# LUXURY APARTMENTS - THE INN

VISION BOOK

# SPECIAL MEETING PRAIRIE VILLAGE PLANNING COMMISSION NOVEMBER 12, 2015

### PC2015-118 Approval of Preliminary Development Plan for 9101 Nall Avenue

North Elevation

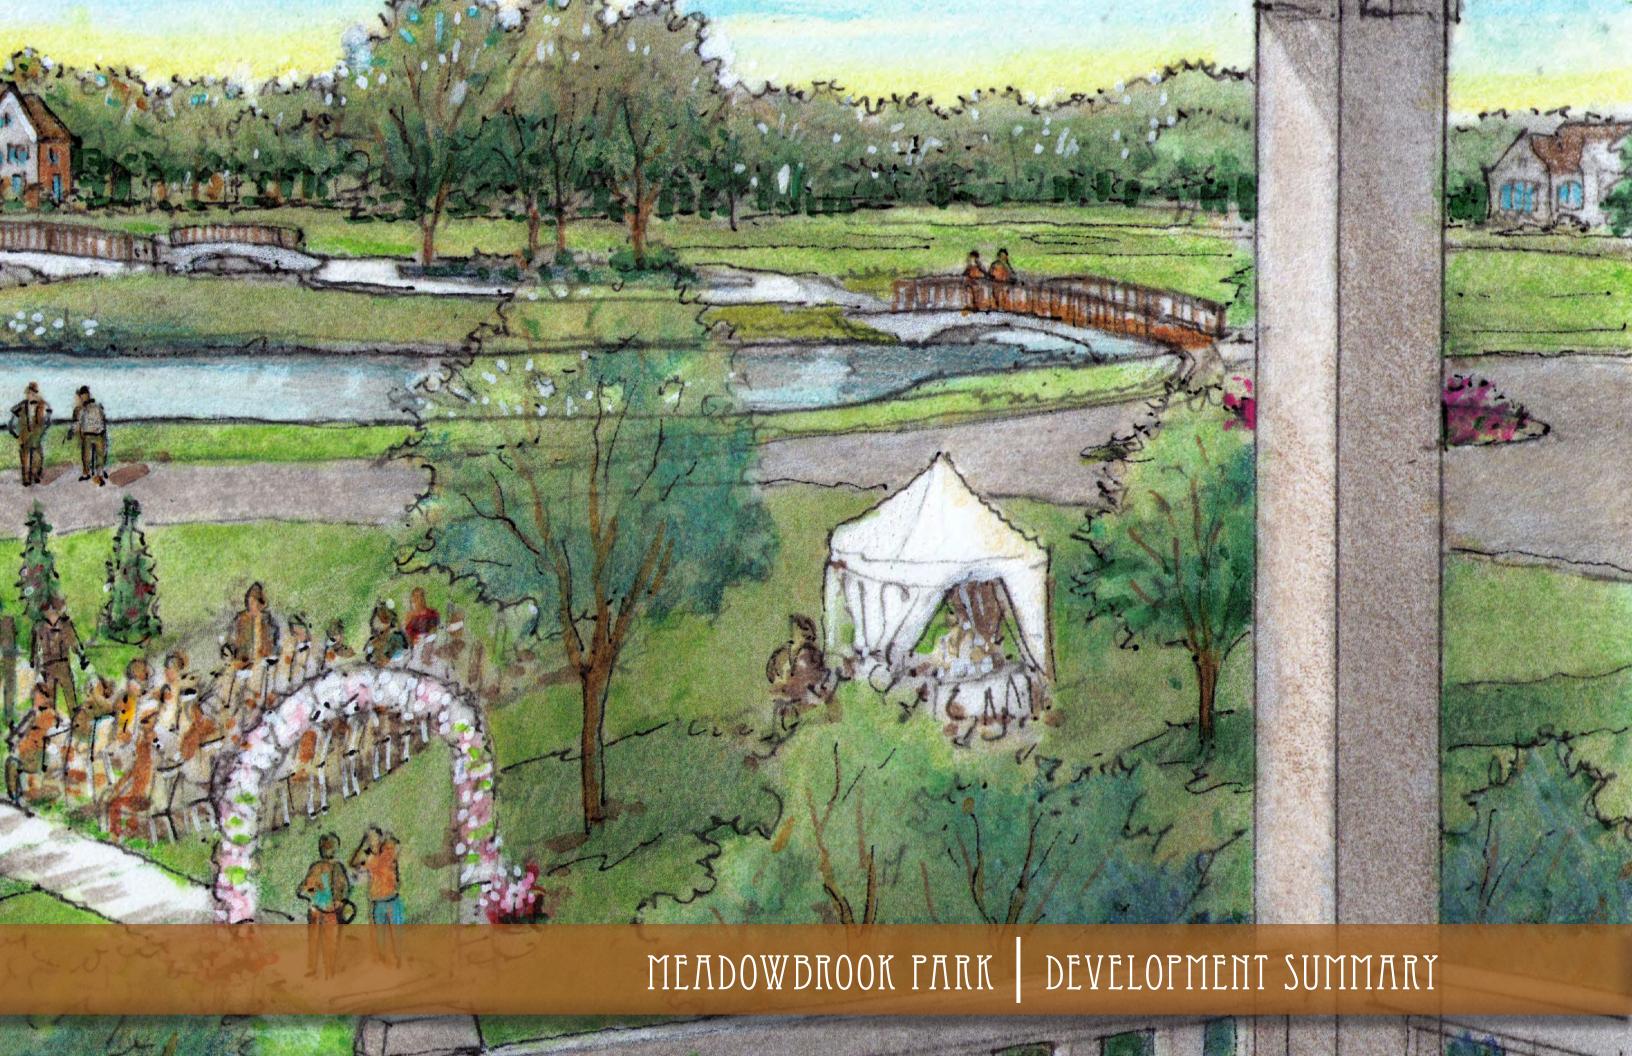
Nancy Wallerstein noted that the plans reflected four different signs on one side of the apartment complex. Justin Duff responded that the notations are meant to be general placeholders of where signs may be located. They are not asking for four signs but identifying possible locations for signage.
